SUBJECT: DIFFERING PROFESSIONAL OPINION RELATED TO TECHNICAL
SPECIFICATION FOR MCGUIRE UNIT 2 (AND PROPOSED FOR
MCGUIRE UNIT 1)

Subject: STAFF REVIEW OF PROOF AND REVIEW COPY OF PROPOSED TECHNICAL SPECIFICATIONS FOR MCGUIRE UNITS 1 & 2

Safety Evaluation Report
McGuire Nuclear Station: Units 1 and 2
Proposed Technical Specifications

FIGURE 2.1-1
 REACTOR CORE SAFETY LIMIT - FOUR LOOPS IN OPERATION
 * Under Anticipated Operational Conditions

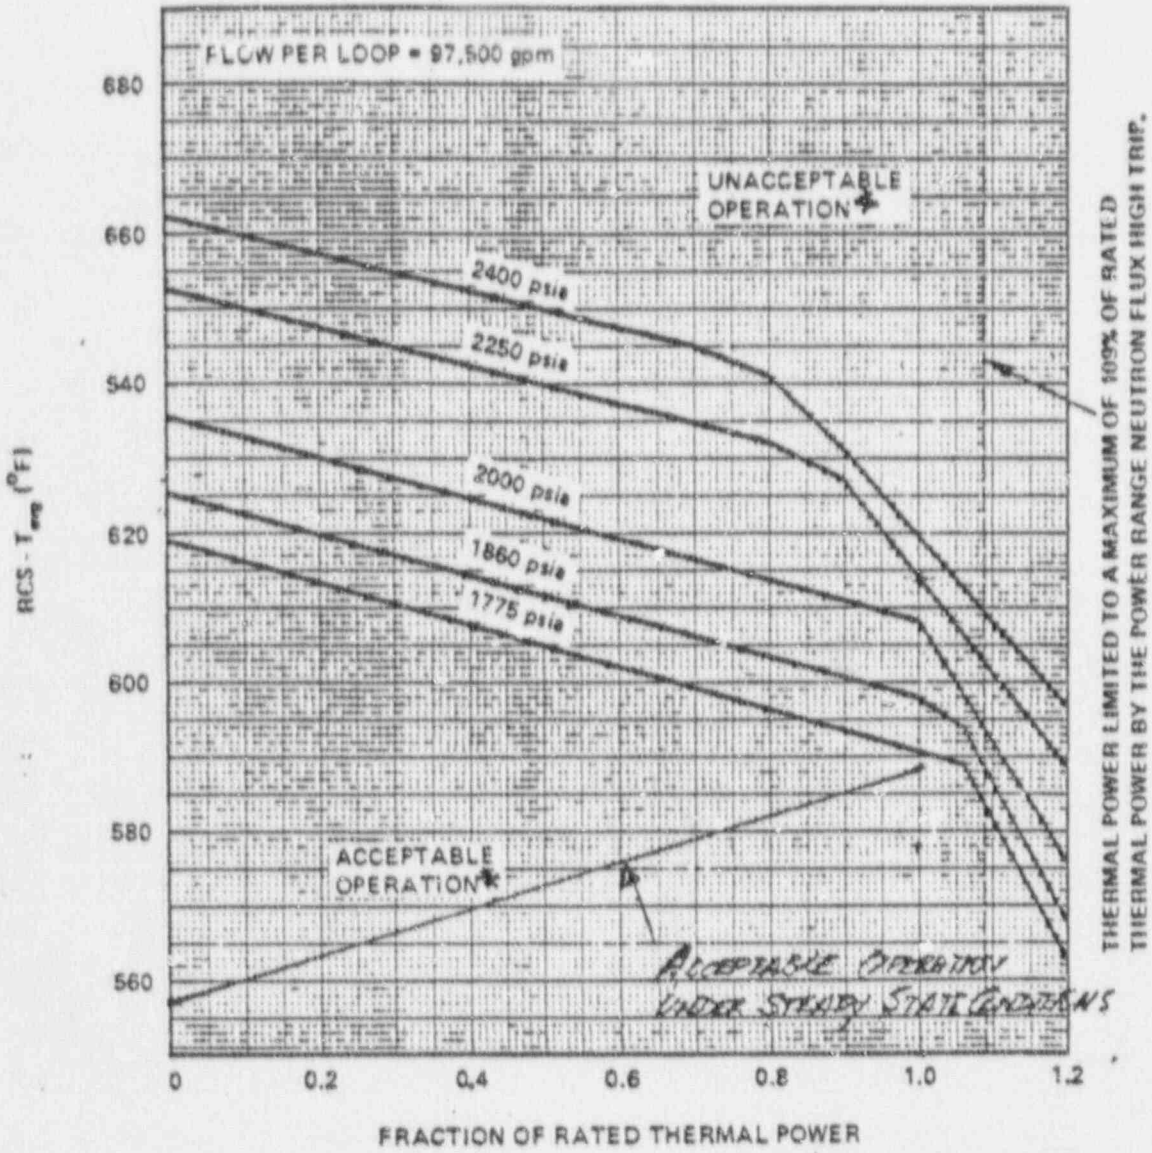
T.S. Pages 2-1, 2: "It is necessary to emphasize that the "acceptable (region of) operation" in Fig. 2.1-1 does not represent an allowable region of Steady State Operation for the reactor core; that actual steady state operation is confined to a very narrow band of operation on the Figure so that the Safety Limits shown are not exceeded under Anticipated Operational Occurrences.

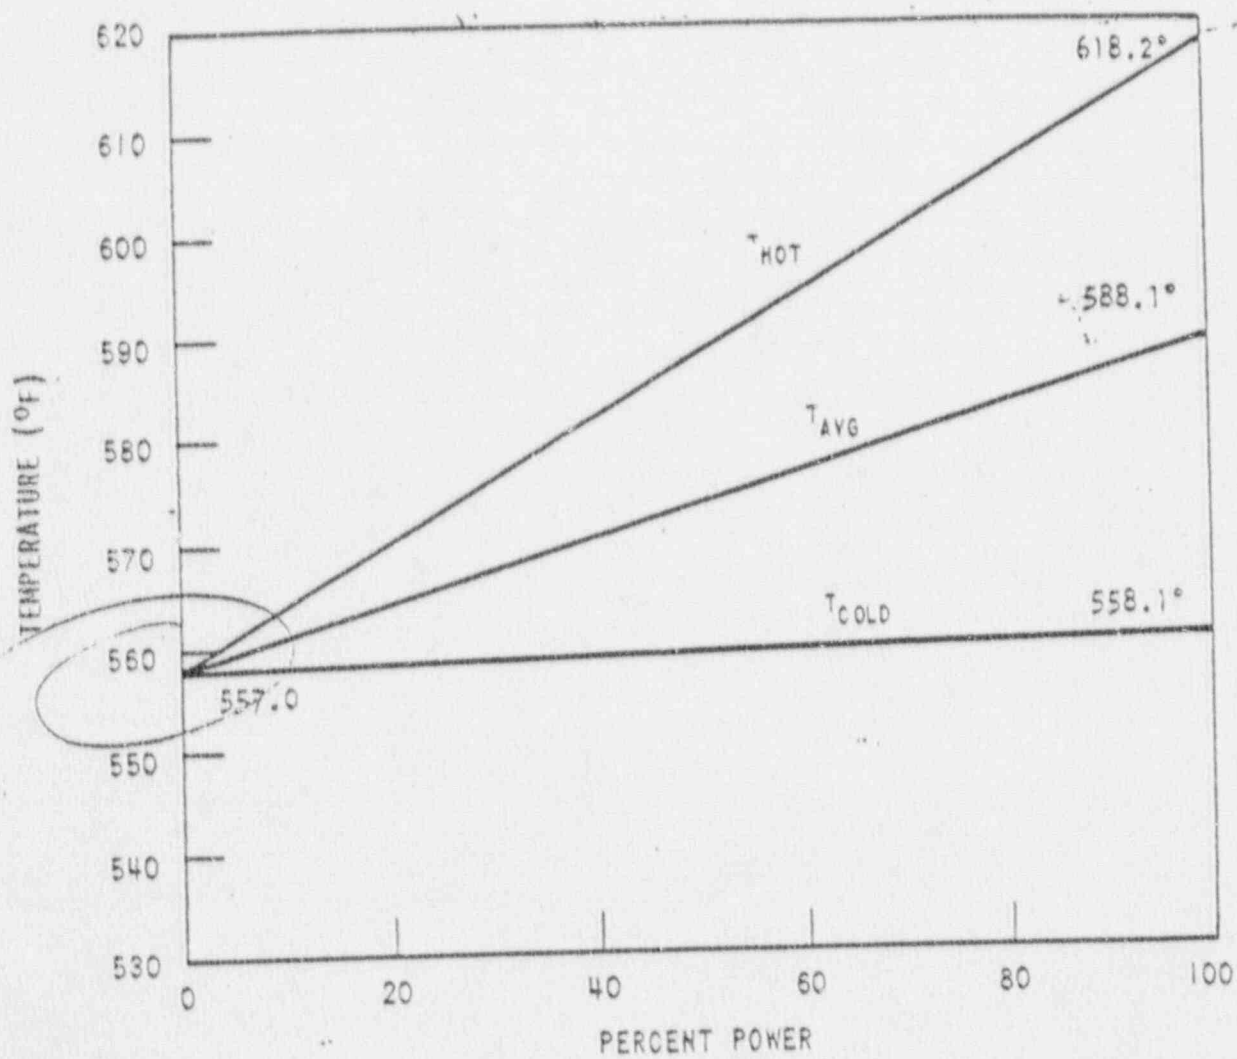
The minimum temp. of 551° F must be reconciled with the value of 557° F for programmed no-load Tavg given in reference 20 Fig. 5.3.3-1.

Values in Table 3.2-1 should be given as indicated (Setpoint) values. Table 3.2-1 shows marked differences from Reference 20, figure 5.3.3-1. These differences must be resolved.

Presumably these are Control Room Instrument Values
 They must be the nominal setpoint values for
 programmed Tavg at NO LOAD and RATED POWER
 levels and the nominal system pressure of 2235 psig,
 which have been the standing before Small ACCIDENT REEVALUATIONS

There is need to clarify apparent ambiguities on the 0% R.T.P. level.
 This is set at approx 551°F, Fig 5.3.3-1 of FSAR says 557.0°F
